Subject: Toxic Substances Control Act (TSCA), Polychlorinated Biphenyls (PCBs) - Cleanup of PCBs at Former Railroad Spur Property, Bay Road, Redwood City, California

This letter serves as the U.S. Environmental Protection Agency Region 9's (EPA's) conditional approval (Approval) of the 2015 PCB Plan and supersedes EPA's 2014 Approval. This Approval is effective immediately and only applies to the entire RSP. EPA is issuing this Approval under the TSCA PCB regulations in 40 CFR 761.61(a) and 761.61(c). Below are the conditions of approval.

**U.S. Environmental Protection Agency Region 9 Conditional Approval
for
Railroad Spur Property, Redwood City, California**

Figure 5-5

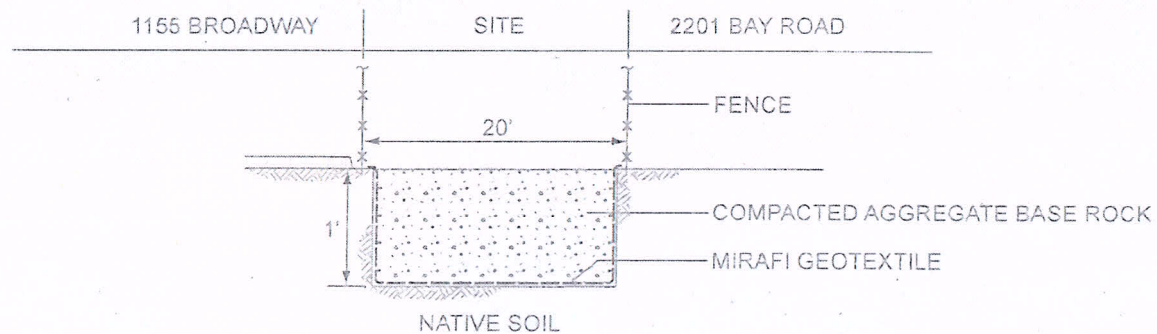
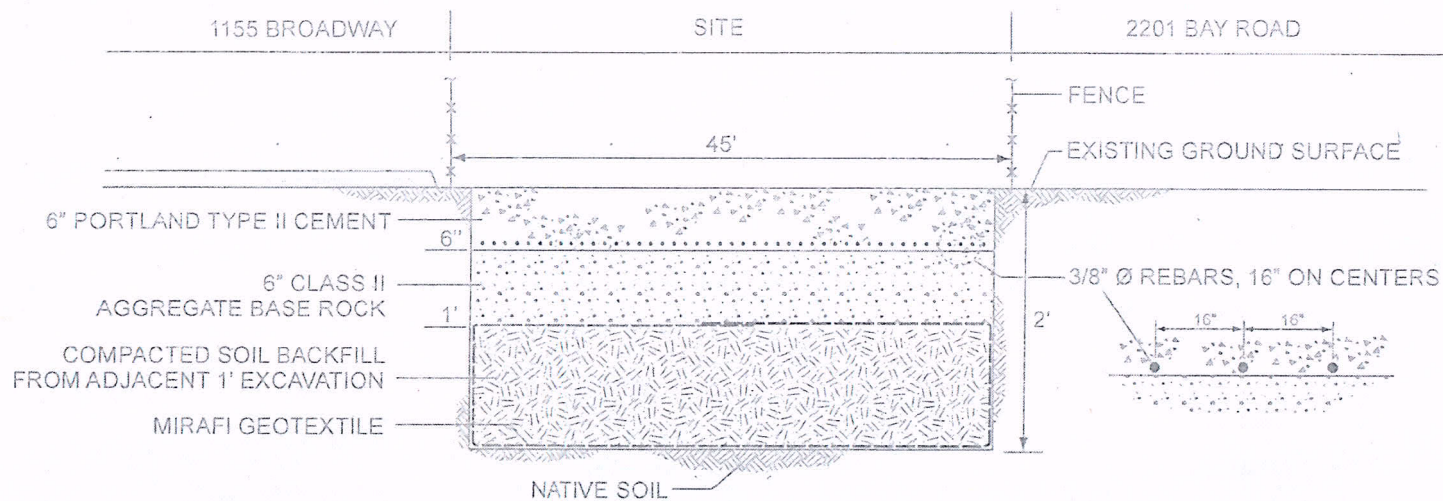
thickness and constructed consistent with the design depicted in the attached Figure 5-5 (Cap and Cover Details) of the PCB Plan. The Land Use Covenant must discuss the onsite disposal of soils from the western excavation into the eastern excavation that are contaminated with PCBs above the cleanup level and below 15 mg/kg total PCBs.
